Addendum #2

MULTIPLE BUILDING LIGHTING RETROFIT MIDDLE TENNESSEE STATE UNIVERSITY Murfreesboro, Rutherford County, Tennessee

ICT PROJECT NO. 180502.11

December 6, 2024

LIGHTING - MTSU SUB LEVEL 1 - PART A
1/8" = 1'-0"

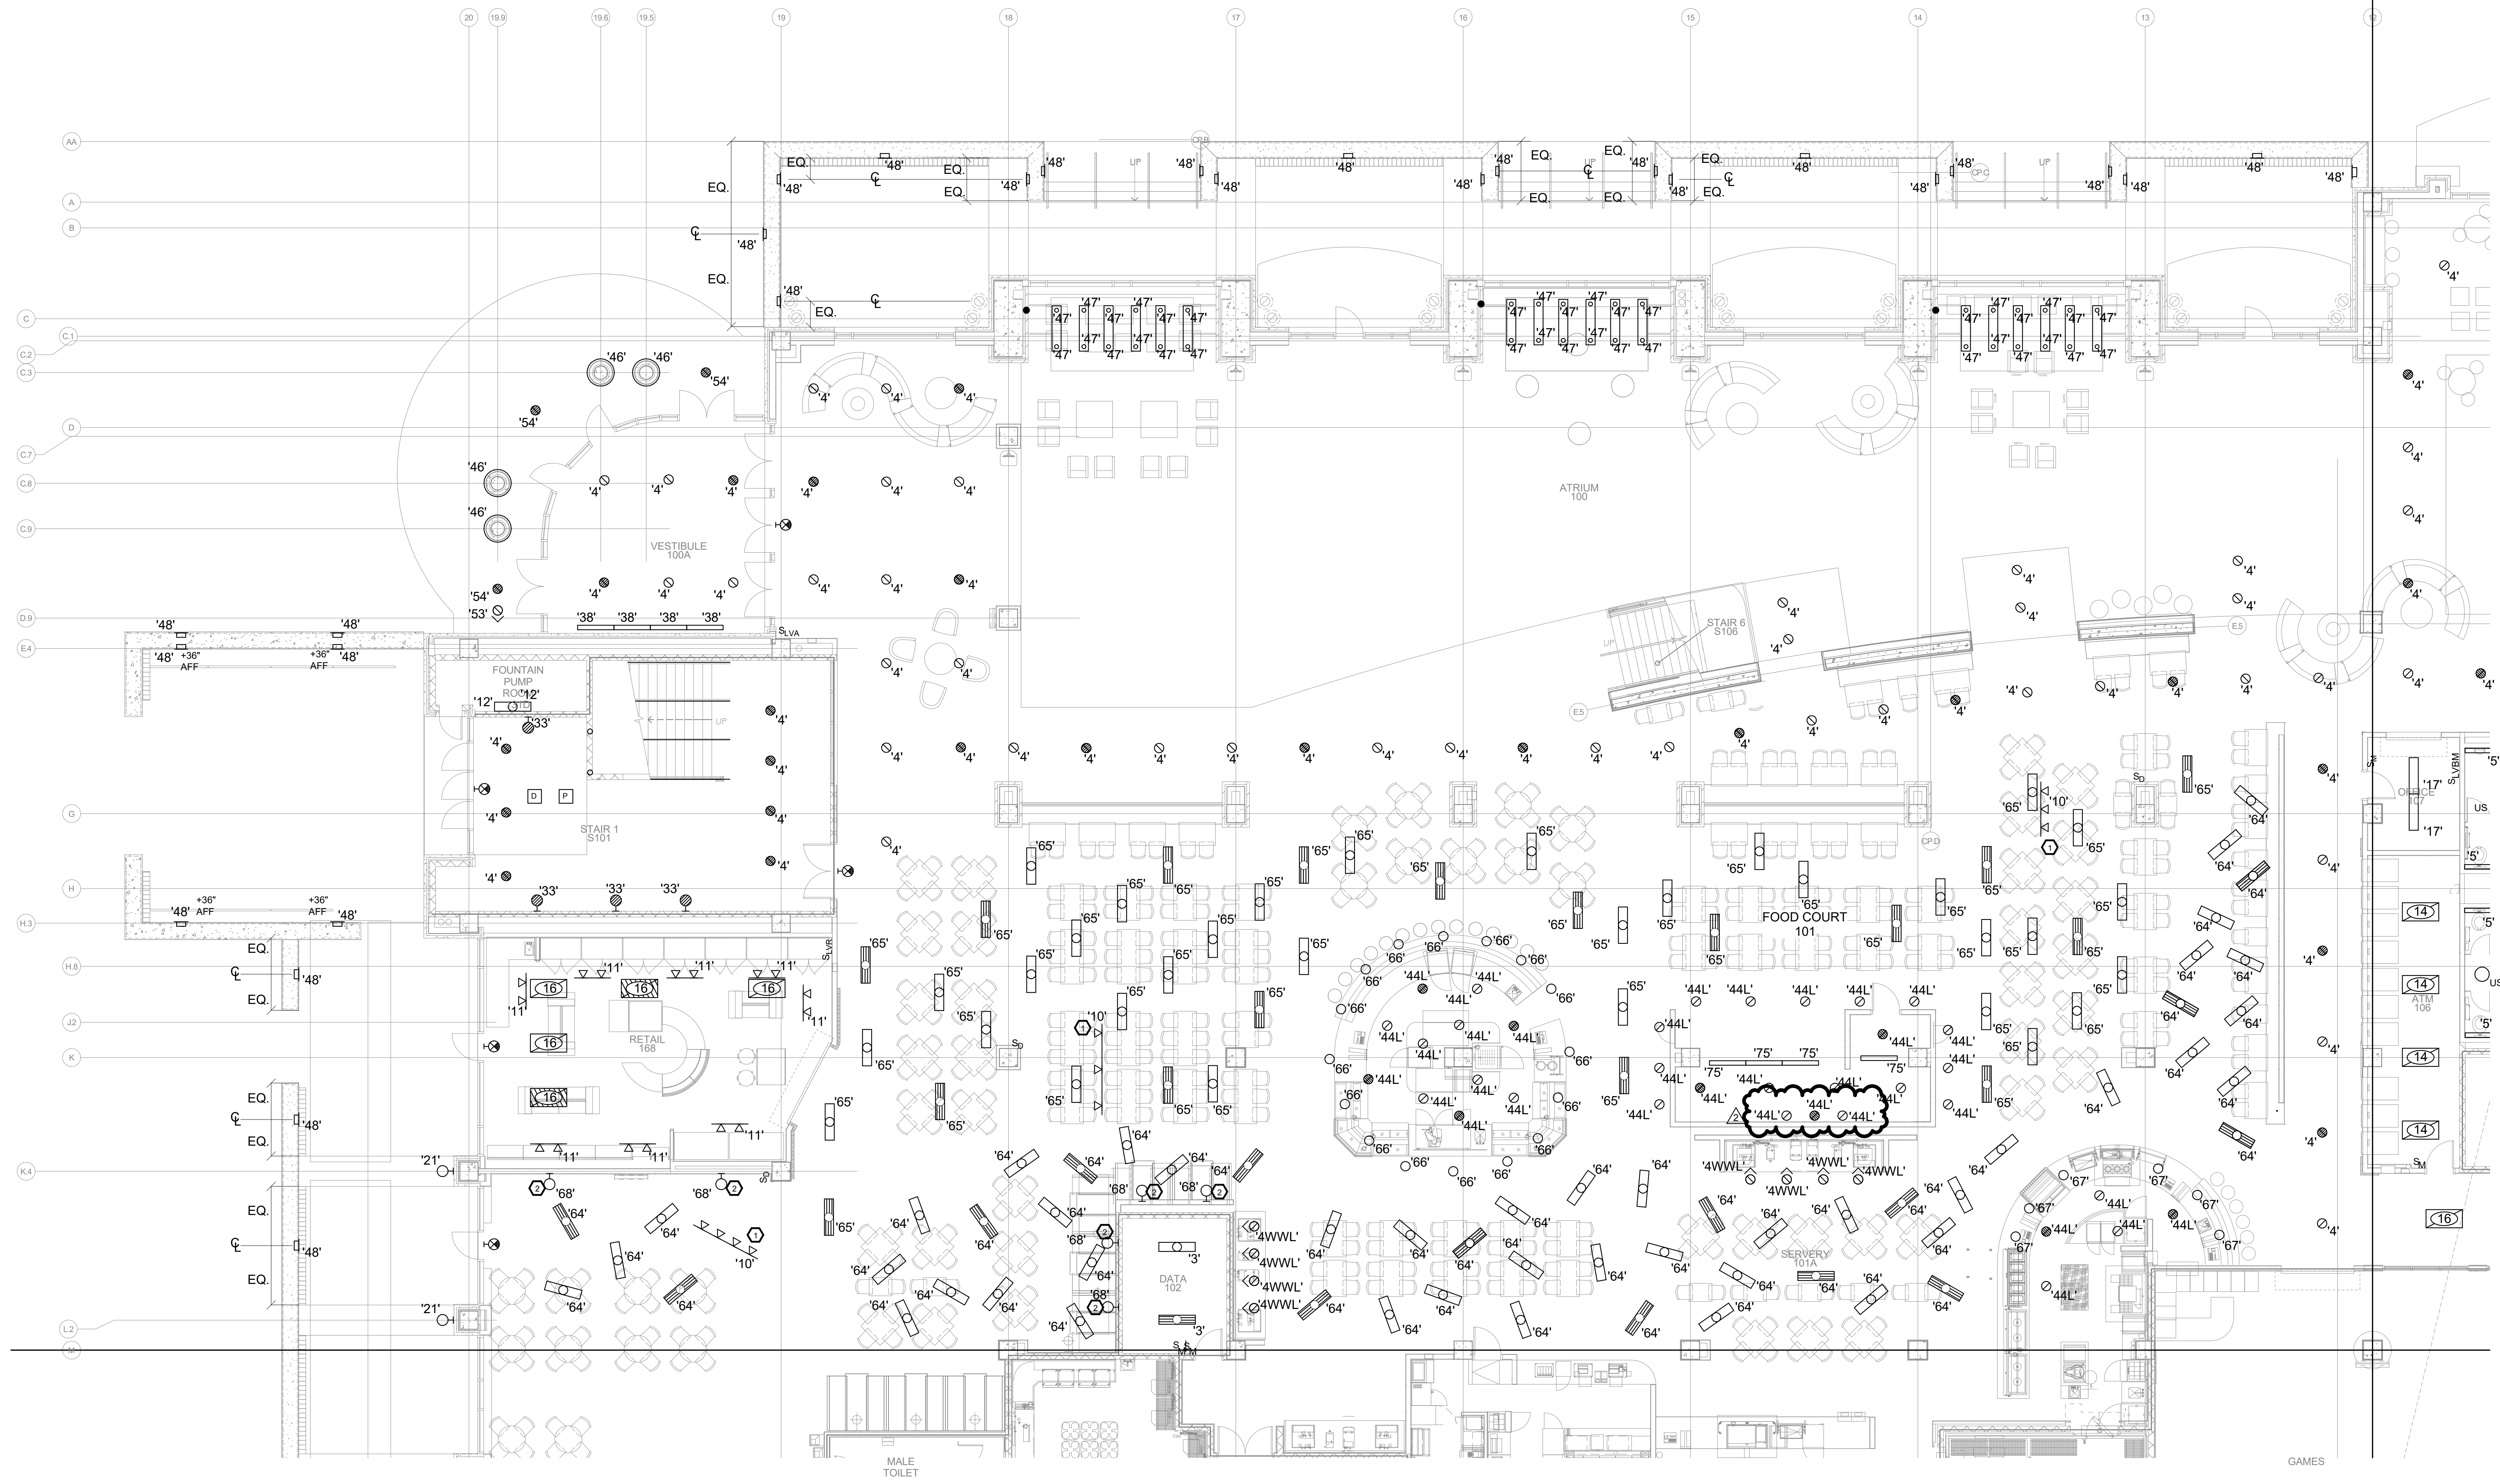
1. On page E101 fixture types '4L' is listed on (3) fixtures just south of the food court. No fixture type '4L' is listed on fixture schedule. Please clarify if these are correct type if so can you provide information on fixtures. ICT Response – These should be type '44L'.

1. E101A – Revised 3 type '4L' fixtures to type '44L'.
2. E101C – Added type '3' in Emergency Electrical Room.
3. E102C – Clarified how the new Pendant in the dining is fed. Added General Note D.

LIGHTING - MTSU SUB LEVEL 1 - PART C
1/8" = 1'-0"

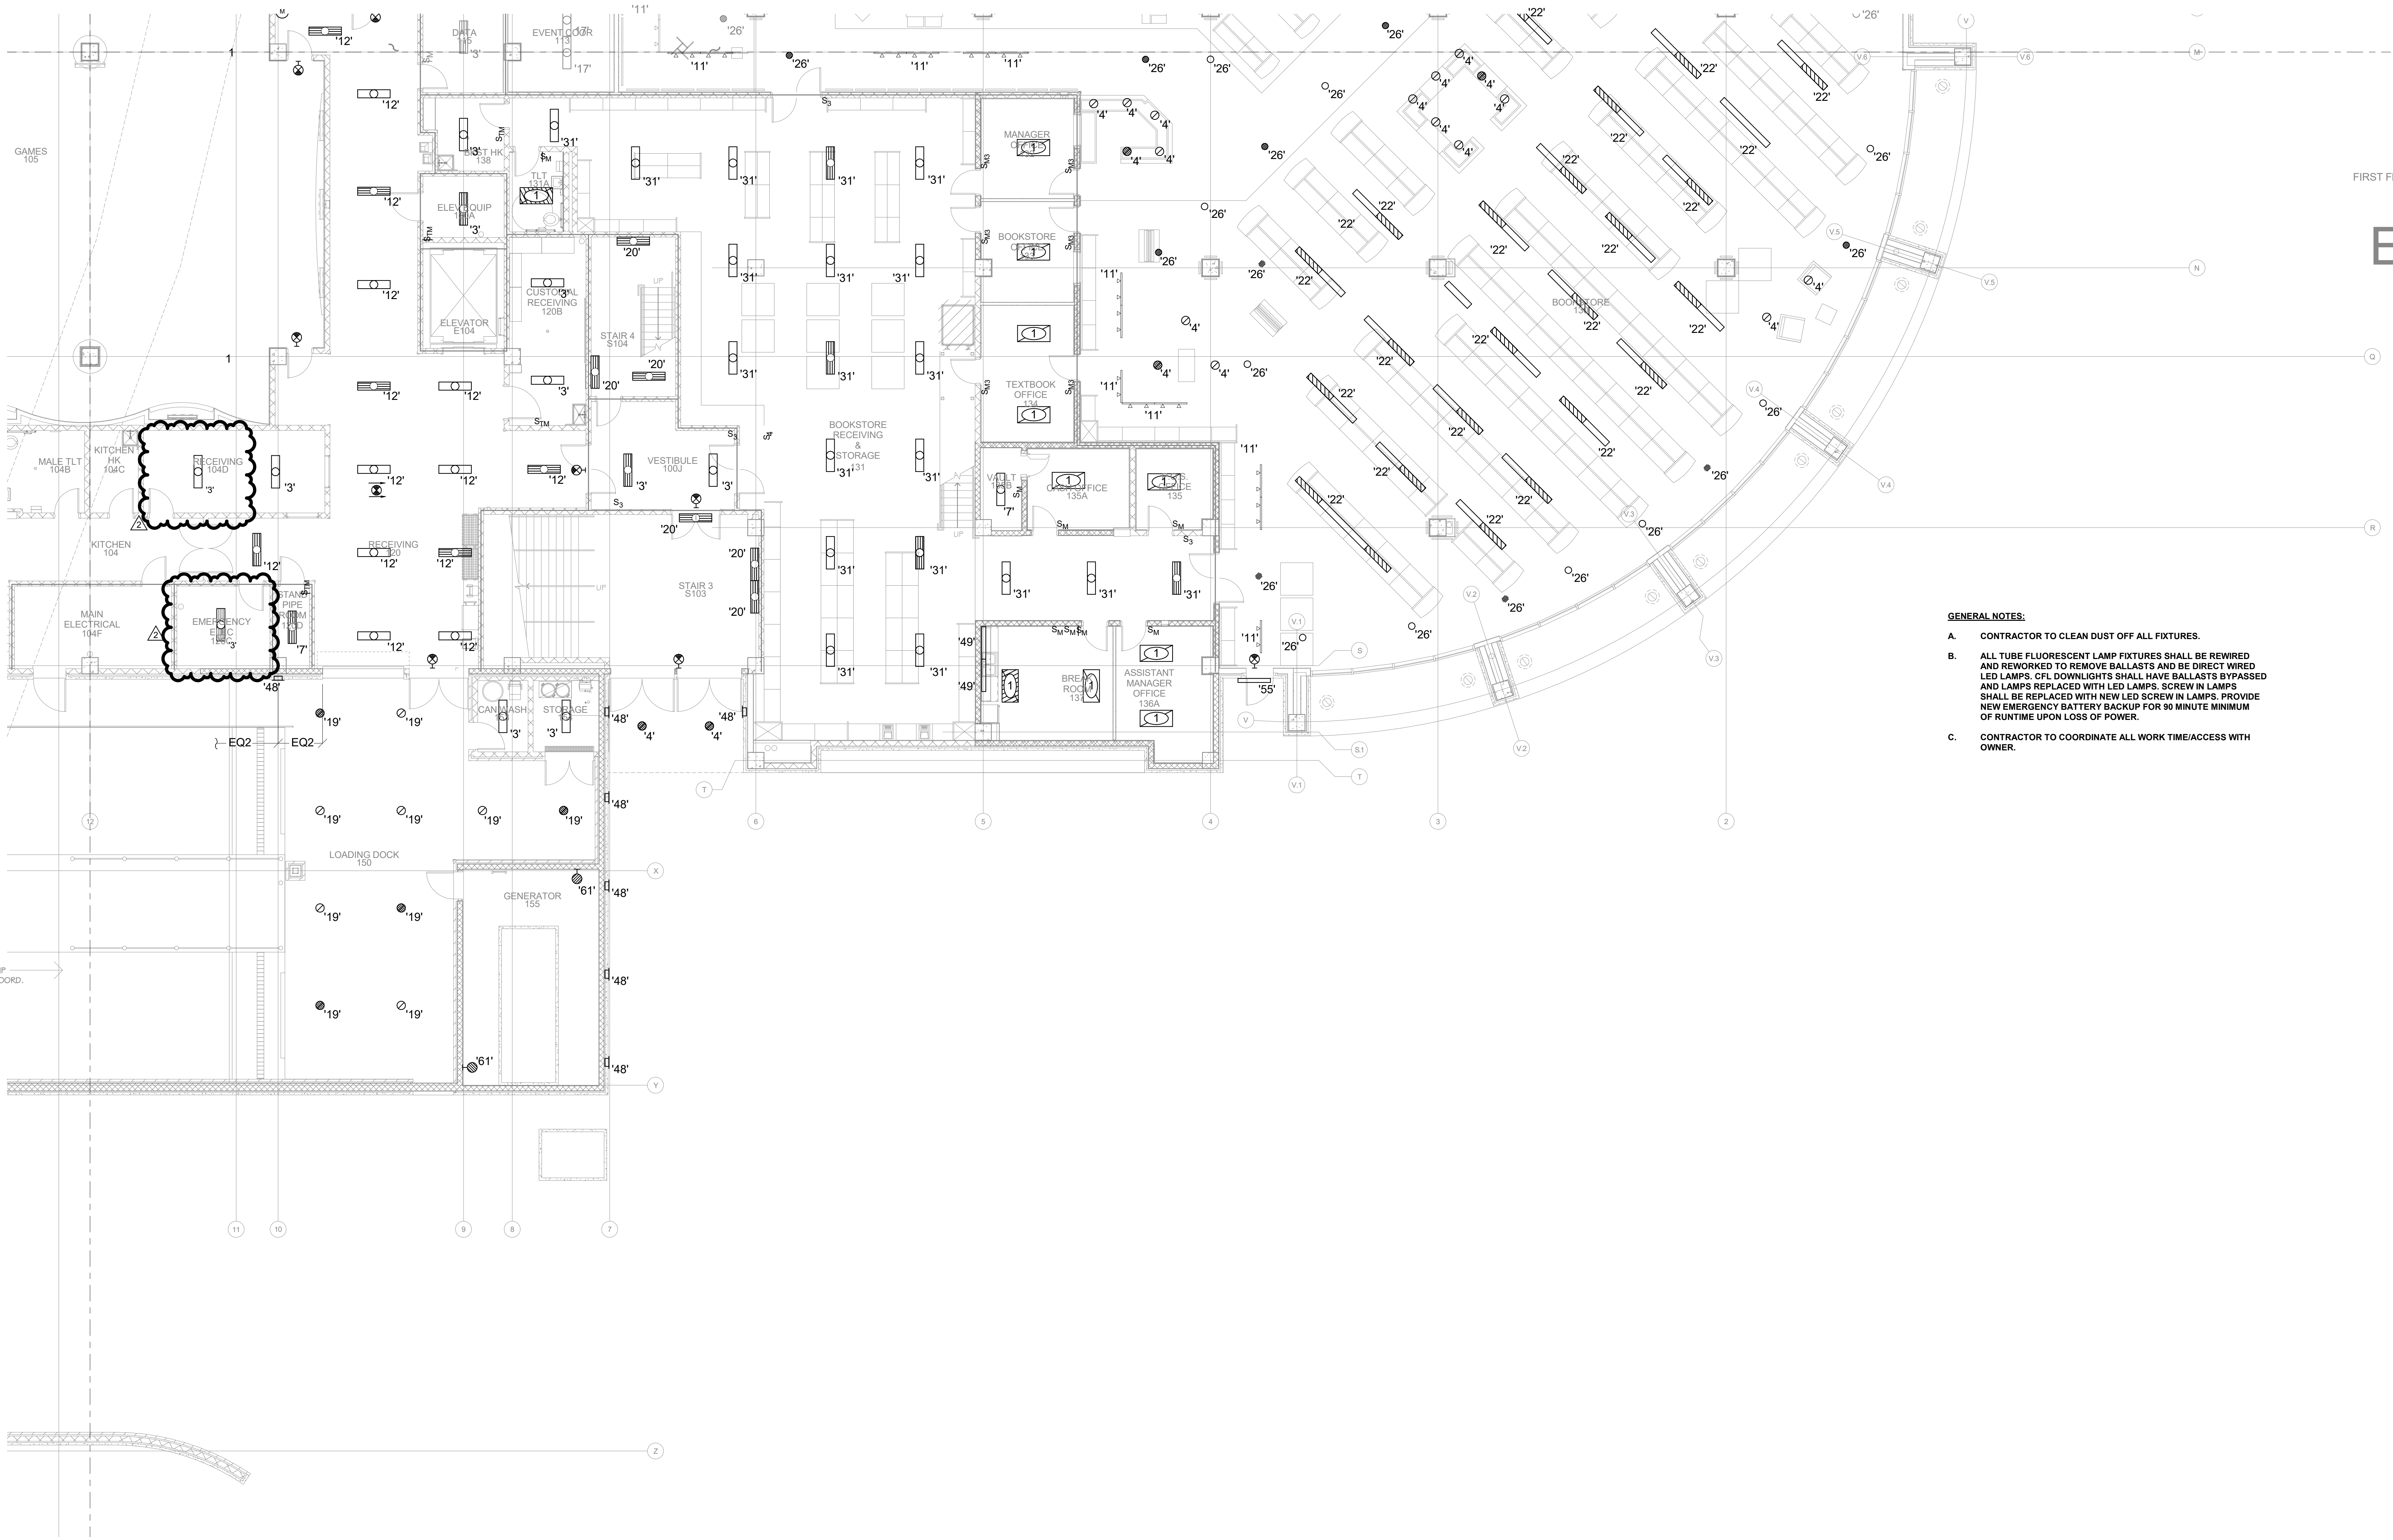
2. Between drawings E101C and E101D room labeled 'Emergency Elec. 120C, no fixtures are show in this room. Also no note description is shown if no work is to be done in this room. Also room labeled "Receiving 104D" only shows (1) fixture type "3" for the room, can we clarify total count of lights in the room? ICT Response – A type '3' has been added to revised E101C for both rooms 120C and 104D. Reference revised drawing.

LIGHTING - MTSU SUB LEVEL 2-PART C
1/8" = 1'-0"

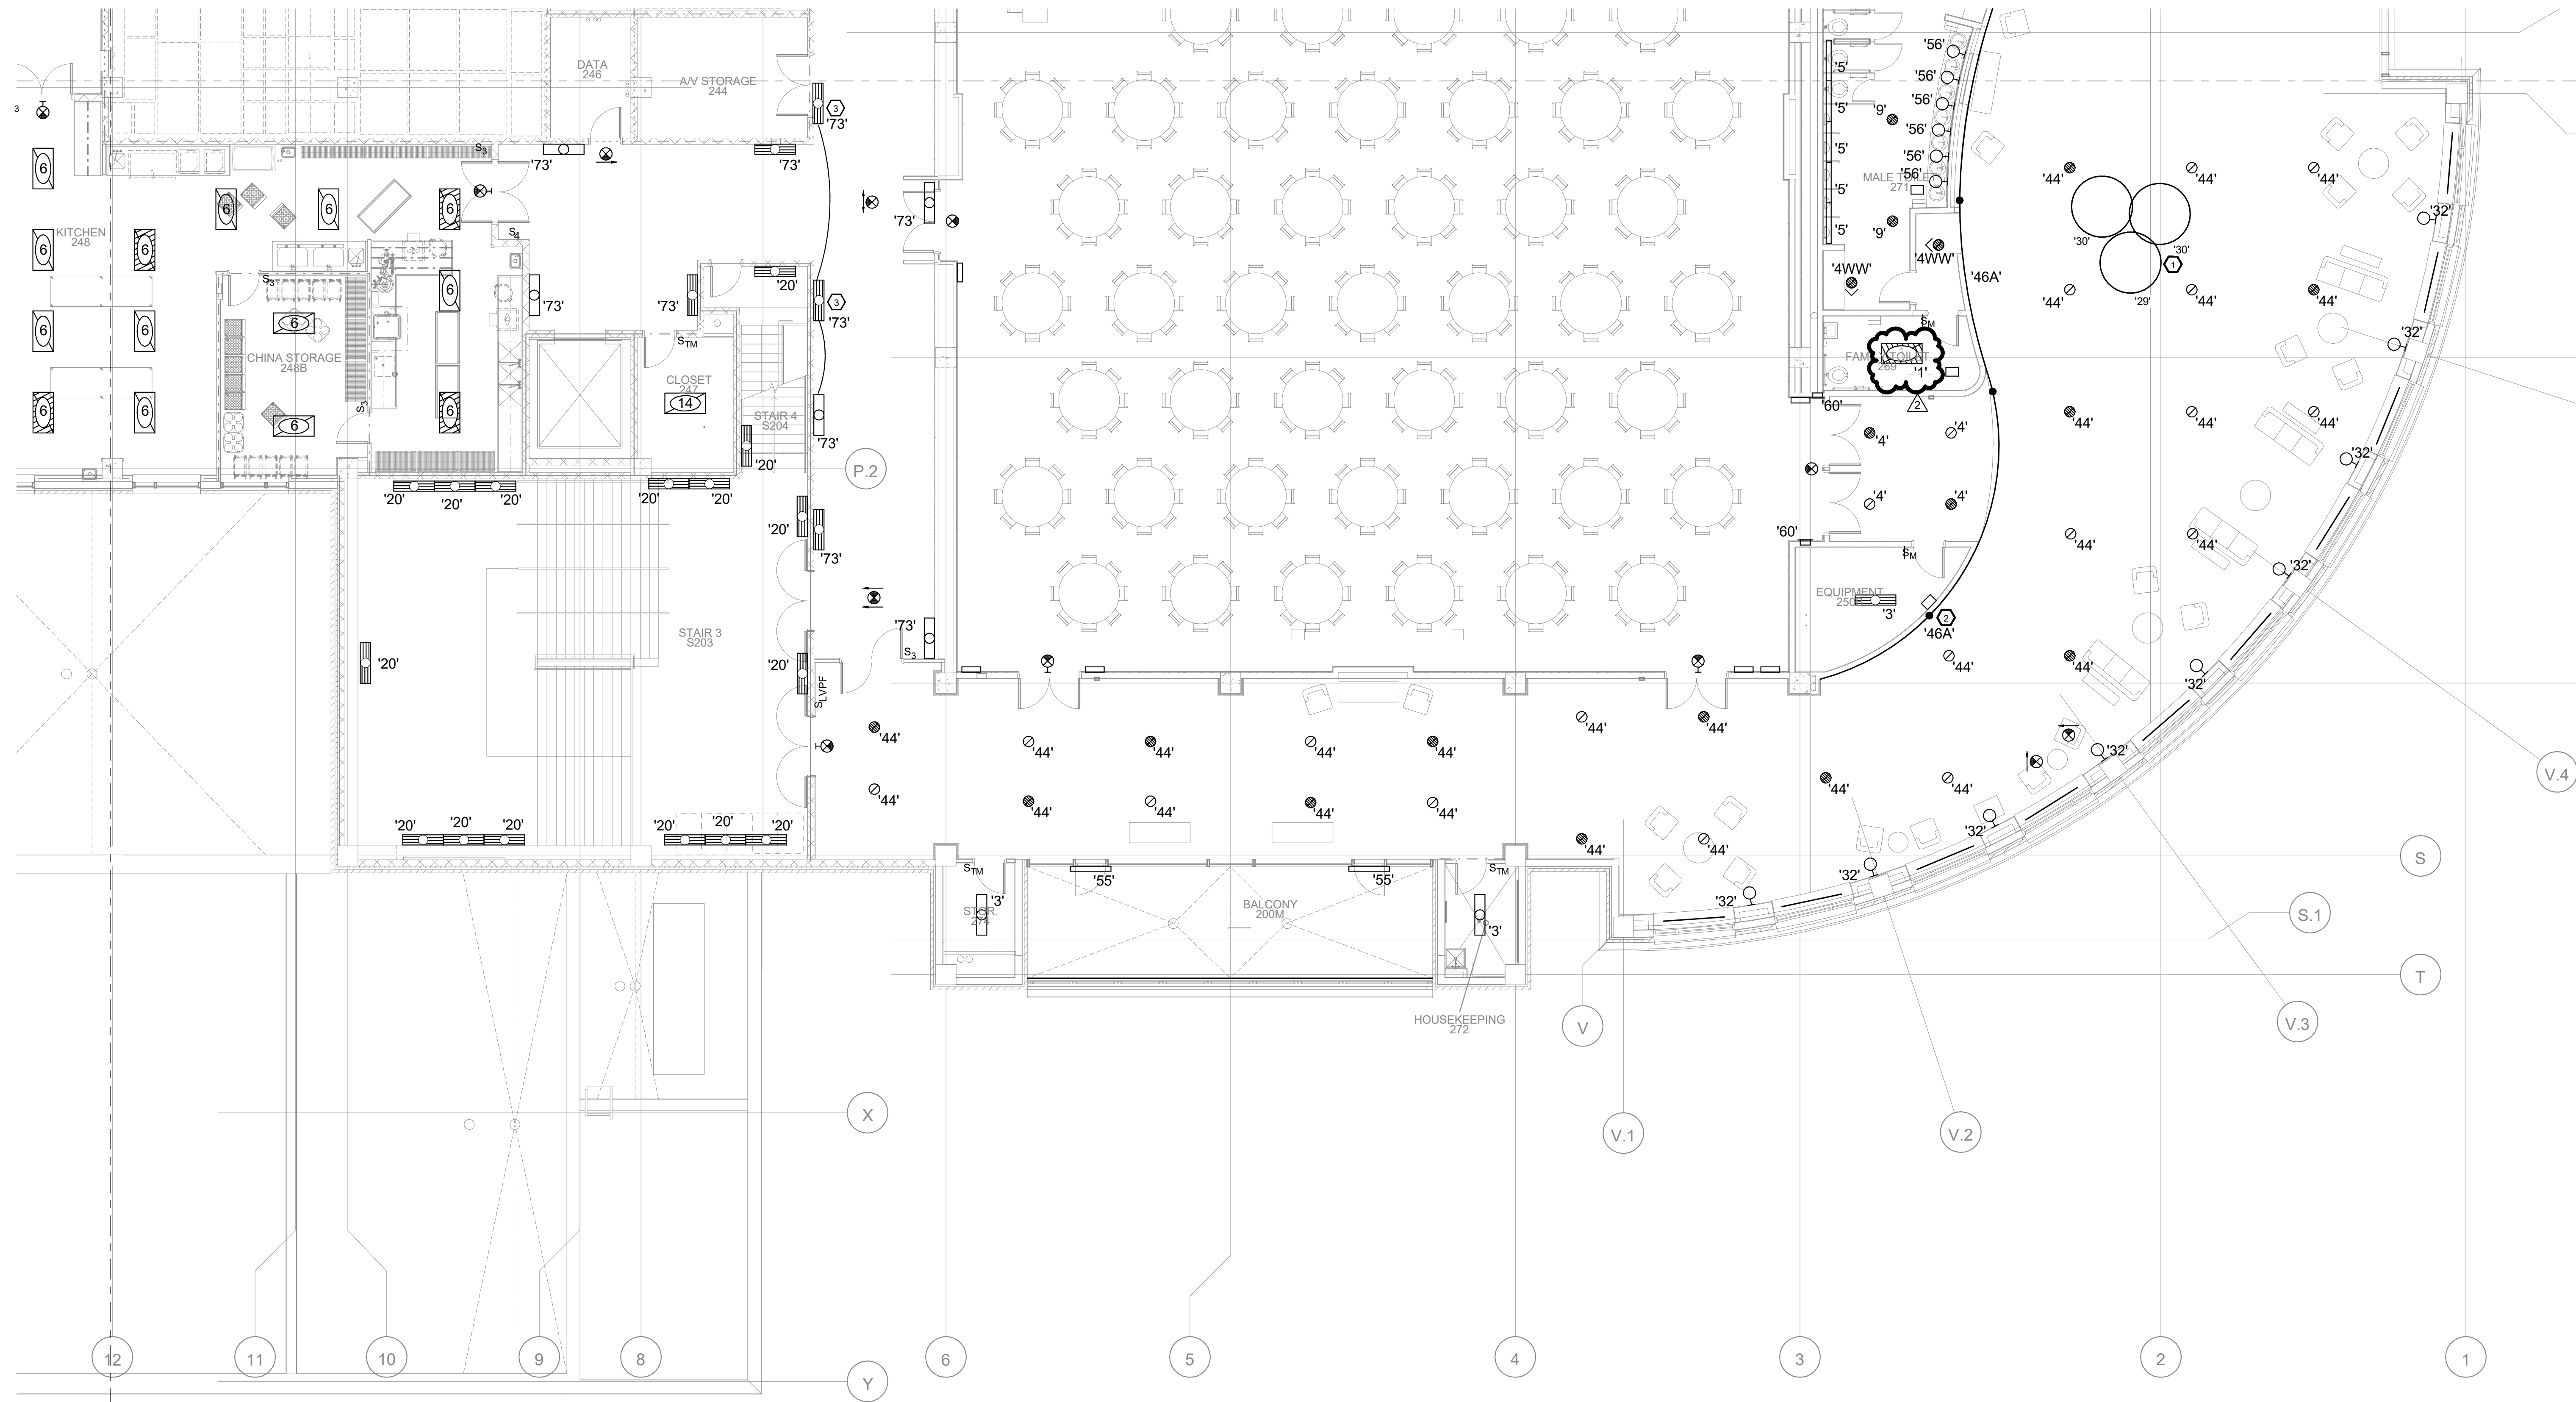
3. On page E102C, fixtures in room "269" no type is given. Please clarify? ICT Response – This is a Type '1'.
4. If any new fixtures require 0-10v dimming is the contractor responsible for providing new dimming cable/ dimming controls and programming? ICT Response – The only rooms with dimming control is Ballroom 250 and Video Theater 208 in the Student Union, the Auditorium in the Keathley University Center, and the Tennessee Room 250 in James Union Building. All others areas are on/off only. Contractor is responsible for integrating dimming and programming for the rooms with dimming existing only.
